PLANNING COMMISSION WORK SESSION MEETING

Tuesday, August 27, 2024 at 7:00 PM

Planning Commission Work Session
SUP 24-01: 71 S. Fifth Street
Car Dealership
August 27, 2024

TO: Casey Squyres, Historic Preservation Planner
FROM: Amber Heflin, CZA, Zoning Official
DATE: July 17, 2024
SUBJECT: Automotive Dealership, 71 S Fifth Street (6984-42-4640-000)
SUP 2024-01
Submission 06/14/2024; 2nd Review

Parking Spaces
(Not to Scale)

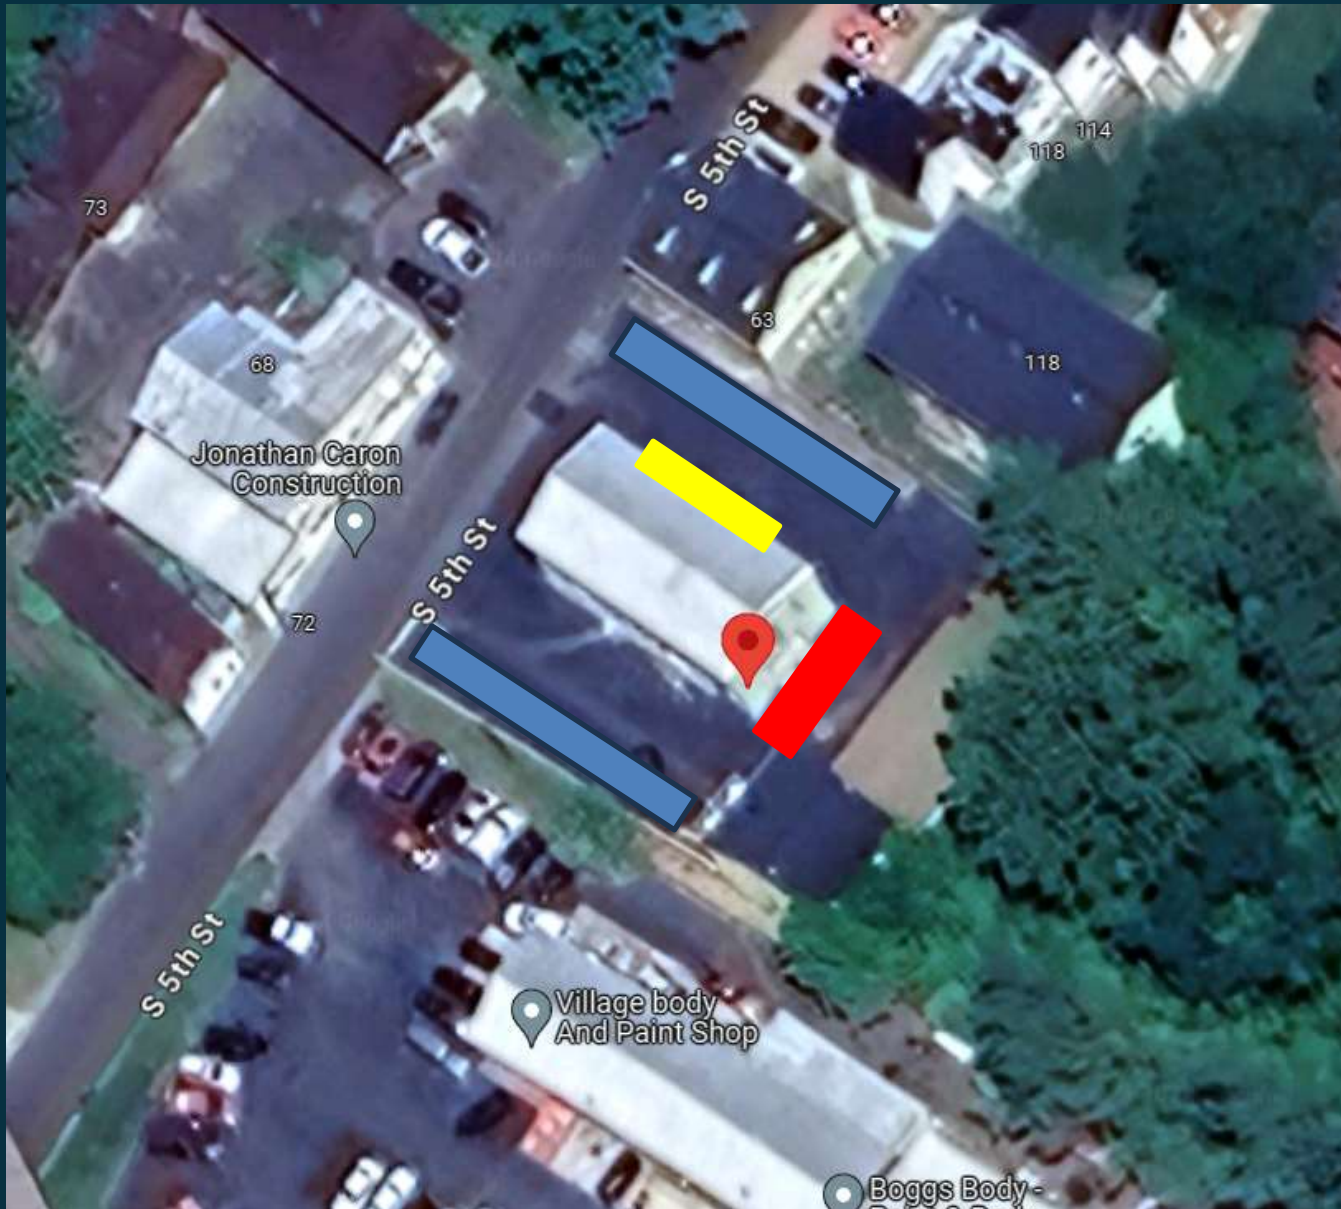
Staff comment: Staff is unable to determine that the site can provide enough parking on the parcel itself to contain the sales vehicles to meet the Zoning Ordinance minimum requirement for auto sales:

Staff comment: Employee parking was not delineated on a plan. Address where the employees for this business will park.

Employees
(4 spaces)

Customers/
Additional
(2 spaces)

Other
vehicles (12
spaces total)

1. Parking Diagram
2. Employees parking can be any of the four spaces in front of building
3. Alternative loading and unloading. I own the lot next door and that will handle additional loading if needed without using public road.
4. I do not intend to use any additional signage.
5. I do not intend to change the lighting
6. I have 24 hour surveillance on the entire property
7. In the last 40 years I have owned the property there has until recently Always been a dealership on this location.

Existing Traffic Flow/Loading & Unloading

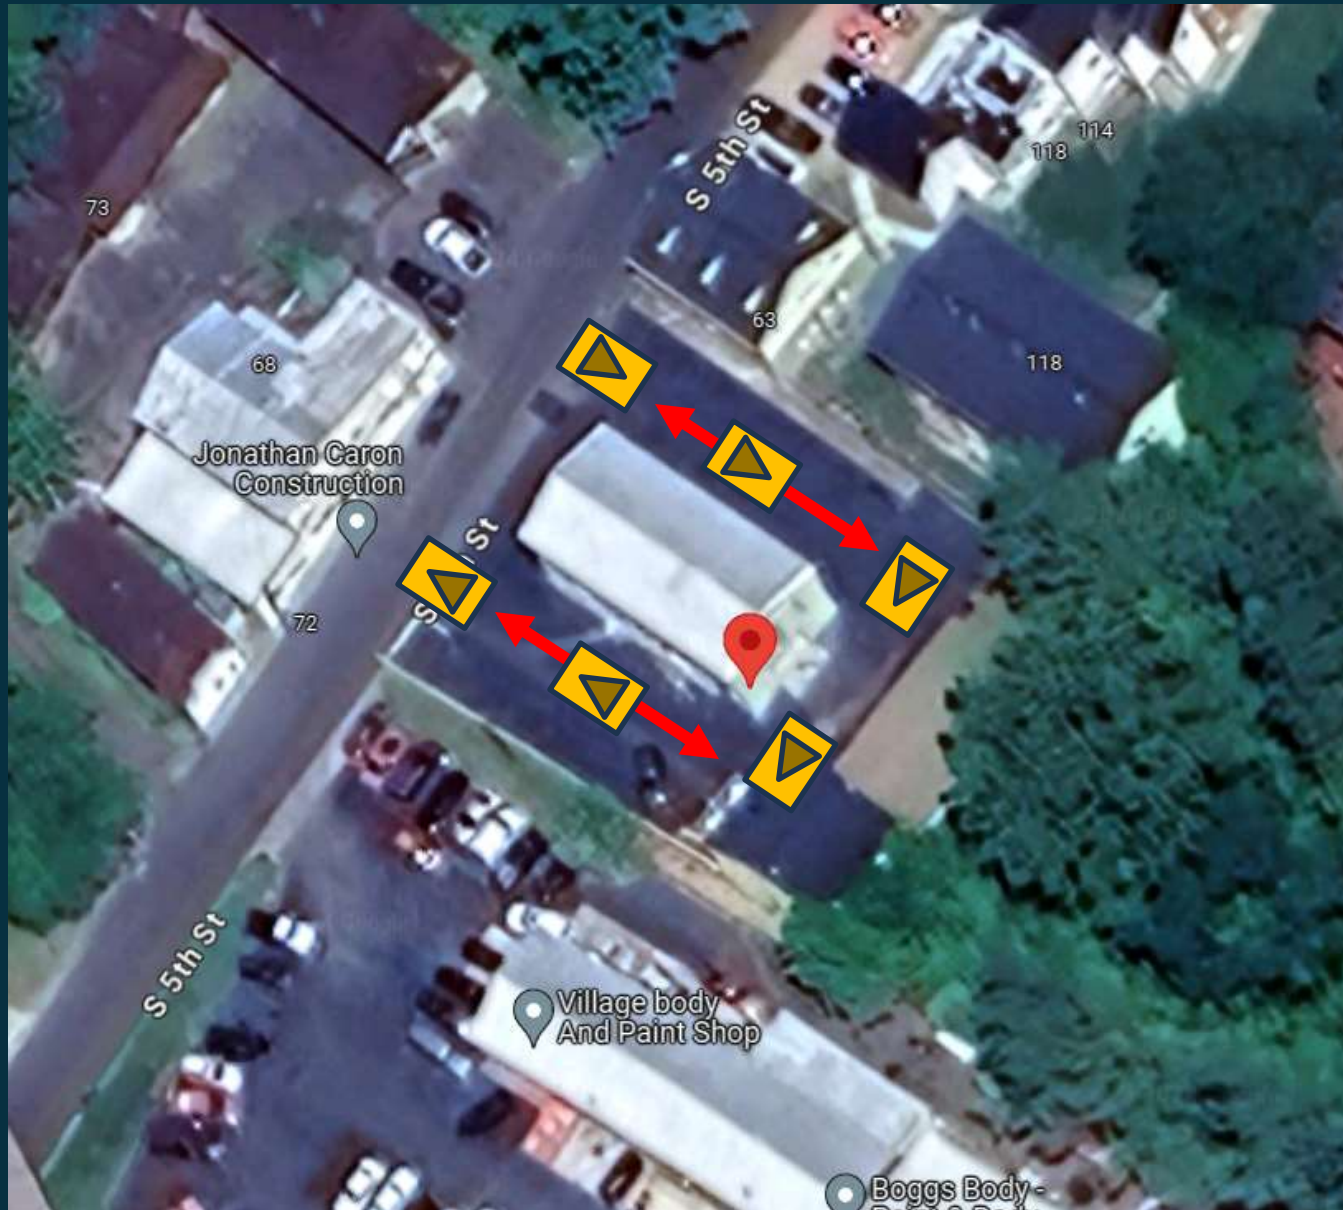
Staff comment: Loading space location was not identified, as a layout plan for the site was not provided. At least one loading space must be identified and cannot block access to a public street or pedestrian walkway.

Staff comment: It appears that the statement of justification and the separate evaluation provided are contradicting when involving the loading spaces. It is unclear to staff if the loading and unloading of vehicles will be within the site or utilizing an adjacent site.

Providing a plan for the site showing the proposed location and schedule of loading/unloading of vehicles will be helpful to staff in determining if loading/unloading requirements have been met.

13. The owner owns lot next store and if needed can use for loading or unloading vehicles
14. No structures needed to be converted
15. The utilities are sufficient and do not need to be modified

SHEET NUMBER: C.04

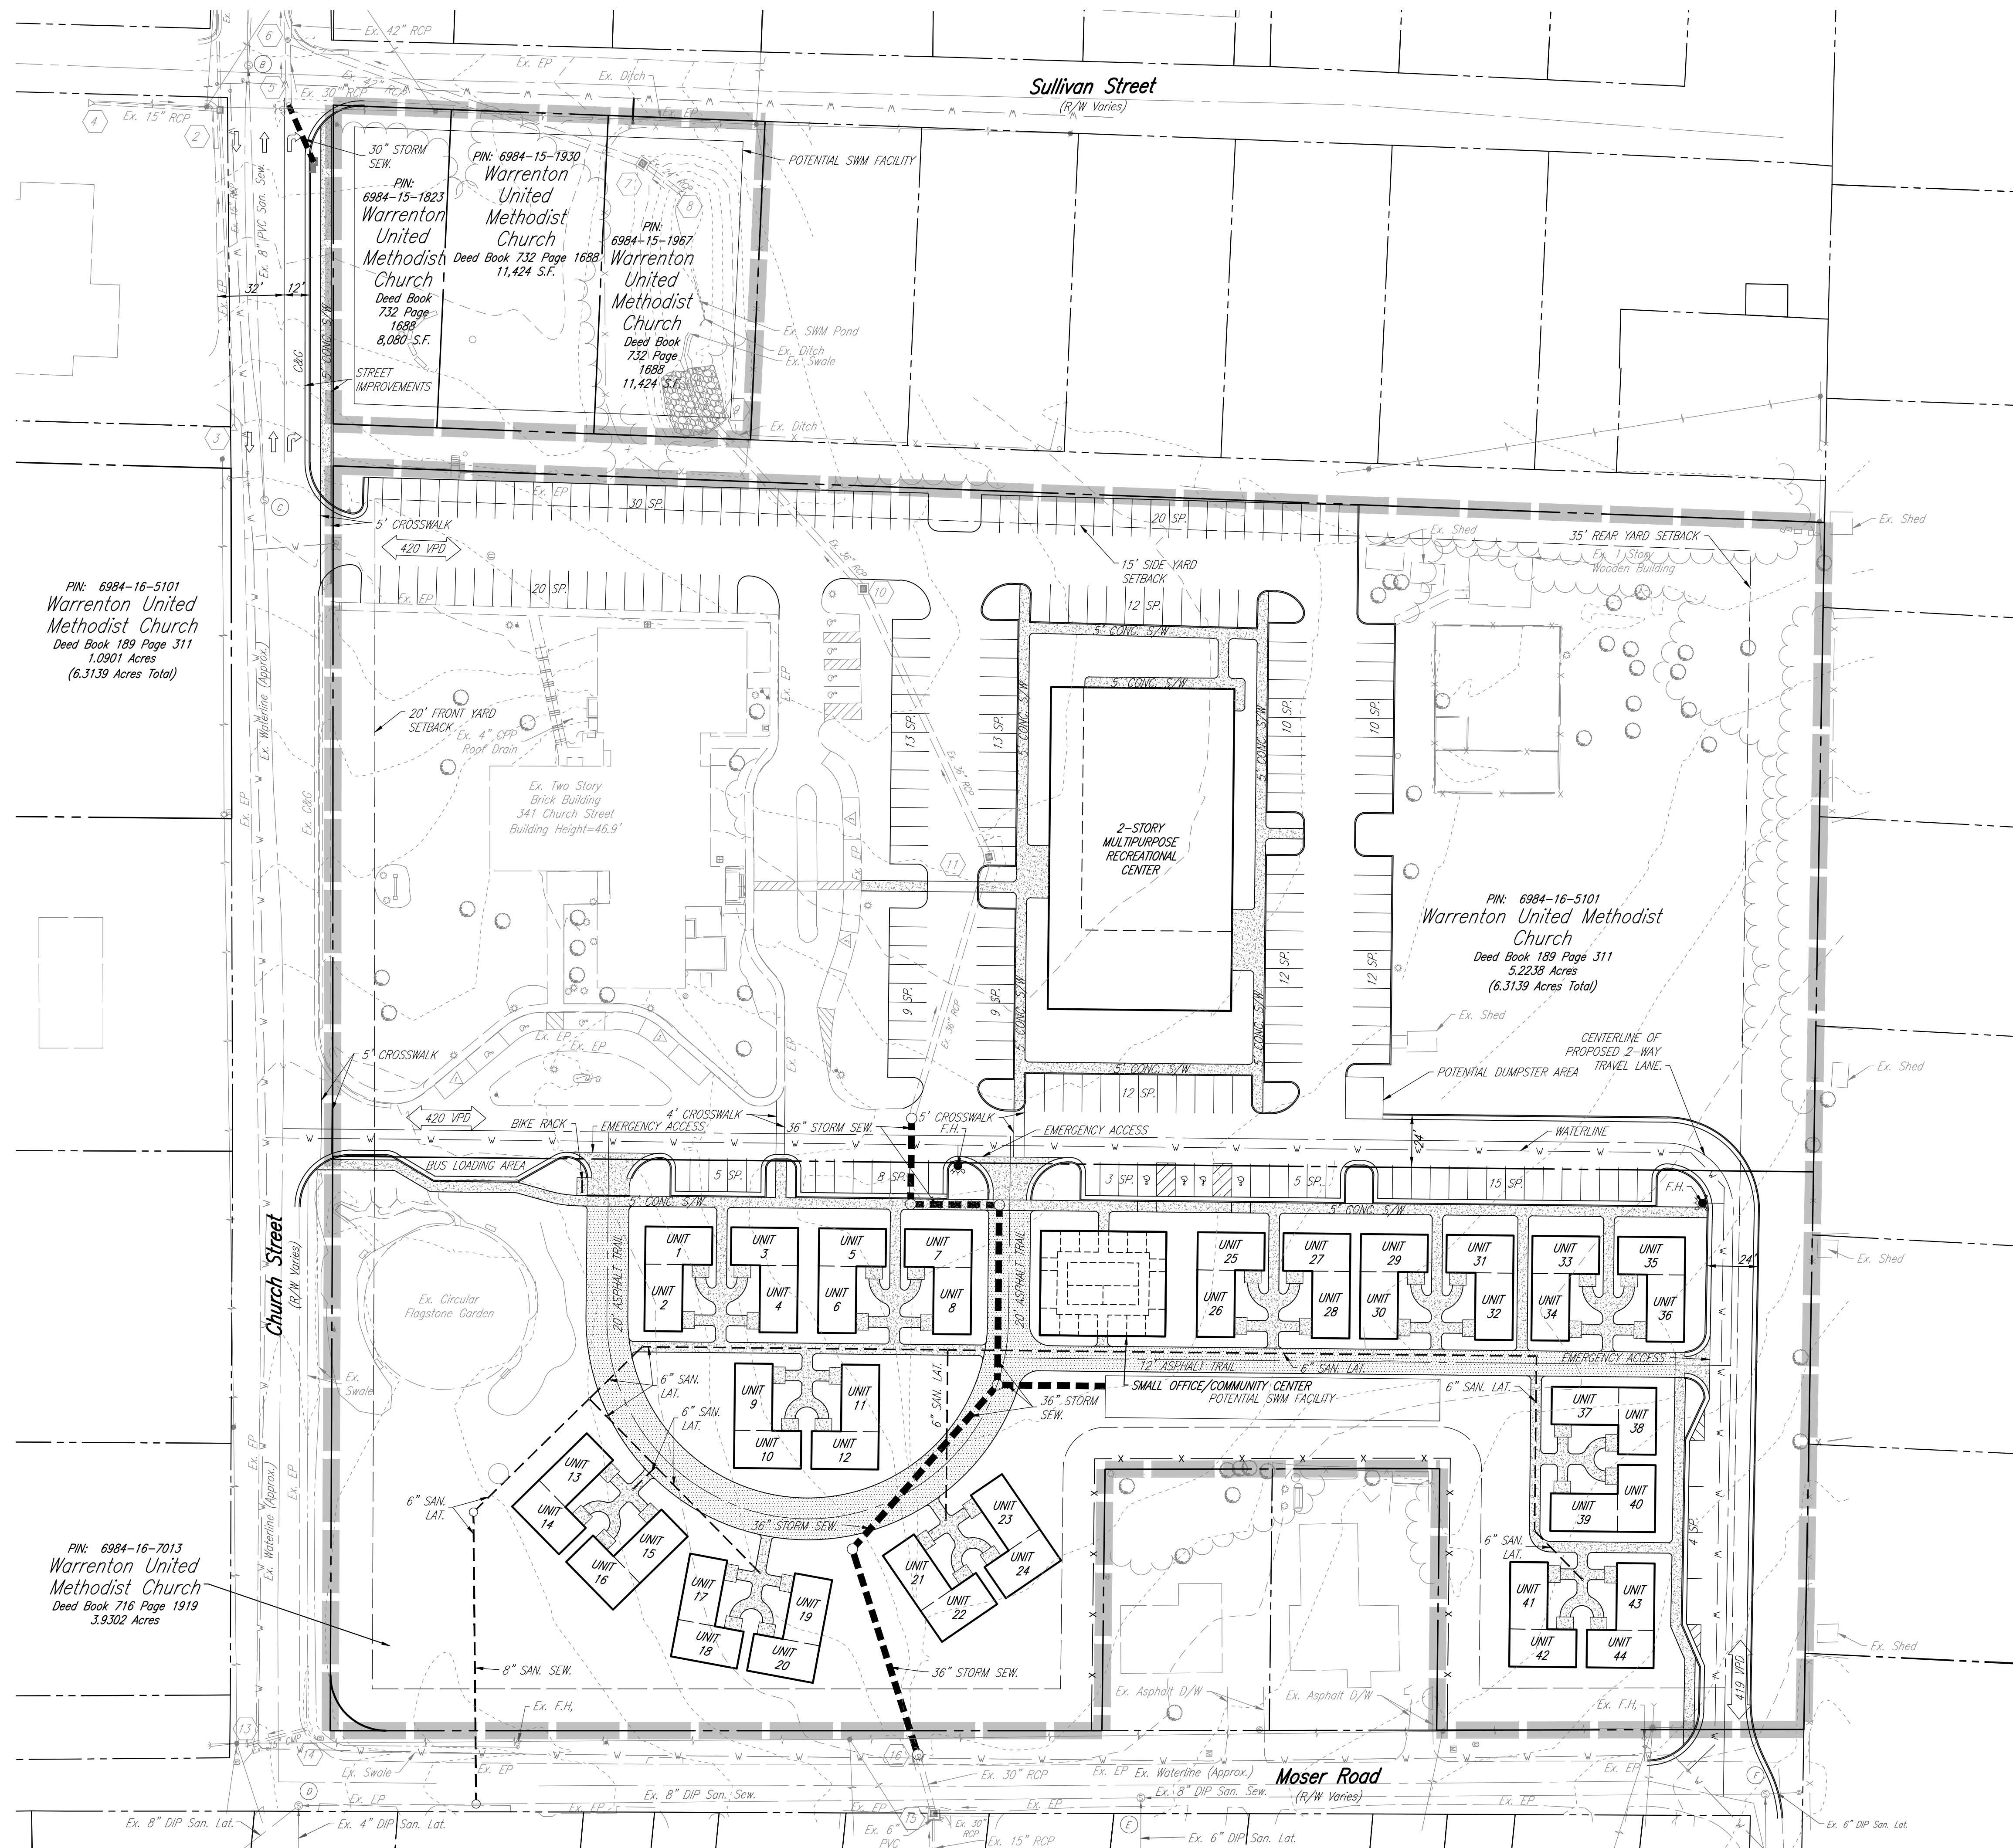
The parking calculations provided as based on the unprovided parking demand study; Staff is unable to verify.	Please see the revised GDP (Sheets C.03 and C.04) where more information on parking is shown. These sheets show the required parking for each proposed use per the Zoning Ordinance. The total parking proposed exceeds the minimum required amount per the Zoning Ordinance.
The applications documents include a description of a bus service; however, the plan sheets do not indicate how this will be accommodated on site with adequate loading spaces and facilities.	<p>Please see the revised GDP (Sheets C.03 and C.04) where a van loading area has been added for clarification.</p> <p>There is no public bus service planned at this time. Hero's Bridge currently uses a 12-seat passenger</p>

The application does not clearly describe how refuse will be addressed on site for all uses. Refuse facilities but must be screened from view	Please see the revised GDP (Sheets C.03 and C.04) where a proposed dumpster area has been added. A trash removal service will be contracted

The proposed plan would be reviewed in more detail when final plans are submitted should this permit be approved.	Acknowledged.
Public Works	
Parking for units 13 through 24 and 37 through 44 is questionable as currently shown. Based on this layout, it would appear there would be strong motivation for routine parking along Moser Road, which the current street design would not support.	Please see the revised GDP (Sheets C.03 and C.04) where more information on parking is shown. These sheets show the required parking for each proposed use per the Zoning Ordinance. The total parking proposed exceeds the minimum required amount per the Zoning Ordinance.
Storm drainage will be a major concern during design development.	Please see the revised GDP (Sheets C.03 and C.04) where a preliminary storm sewer alignment has been added.
